WHITE PAPER

PROPOSED MODIFICATIONS TO MOD-029-1a

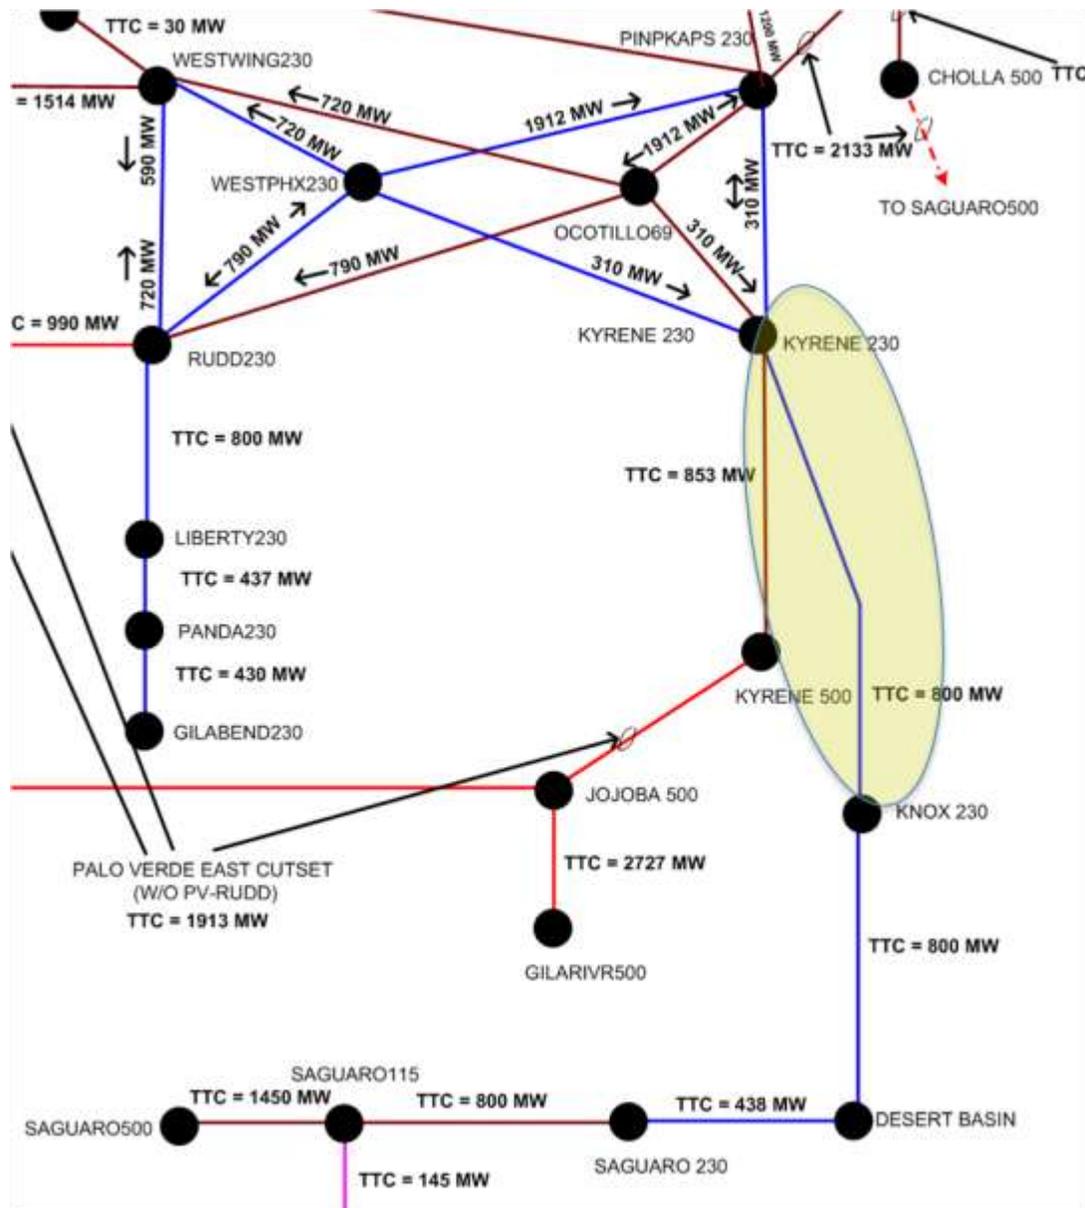
- 1) ATC that has been historically been available in the Contract Path world is eliminated or significantly reduced.

Knox 230kV – Kyrene 230kV

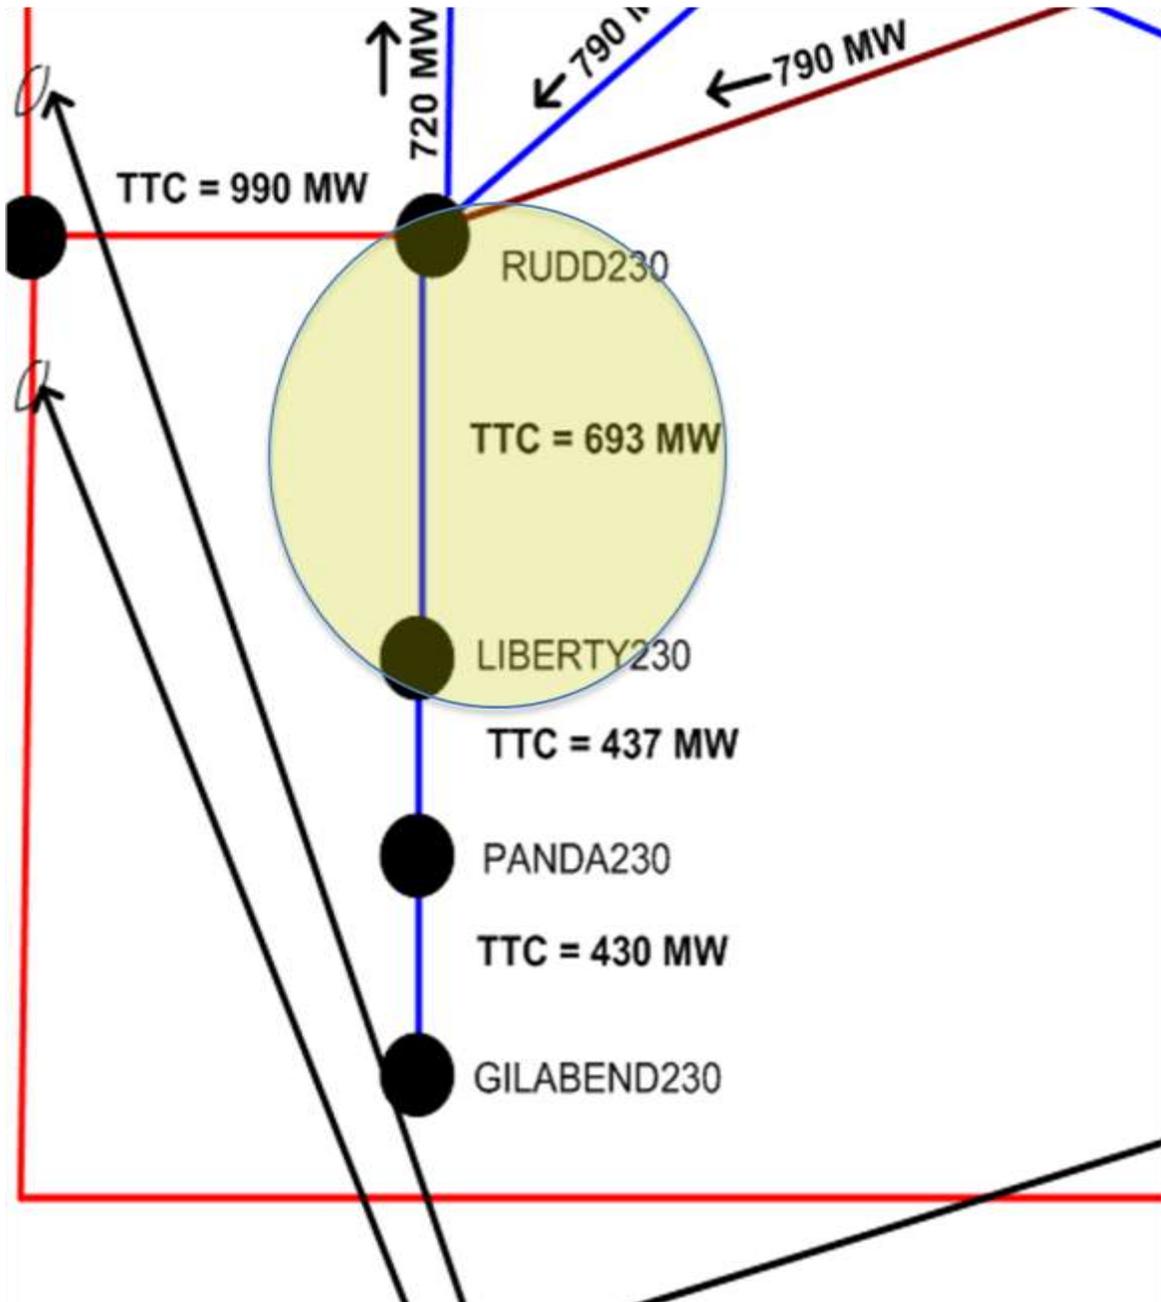
Current TTC: 800 MW (Facility Rating)

- MOD 29 TTC (w/o Waiver/Exception: 183 MW (Flow limited))
- Path consists of 230kV circuit internal to Phoenix Network
- APS owns 100%
- SRP schedules Desert Basin Generation (600 MW). APS uses the remaining for load serving and to bring Saguaro generation resources to Phoenix.
- Maximum real flow for 2010: 100 MW

The Knox 230kV to Kyrene 230kV APS posted path is impacted by the implementation of MOD-029-01a. This path historically has an 800 MW TTC value, which was based on the Facility Rating of the facilities on the path. Under MOD-029-1a (no Waiver/Exception) the Knox to Kyrene path is studied, a reliability limit is not found and a maximum flow of 183 MW is achieved. With TTC equal to flow, the MOD-029-1a (no Waiver/Exception) TTC value on the Knox-Kyrene path is 183MW. There have been long term contracts of 600 MW, and 200 MW of APS load serving historically scheduled on this path, with no reliability issues.
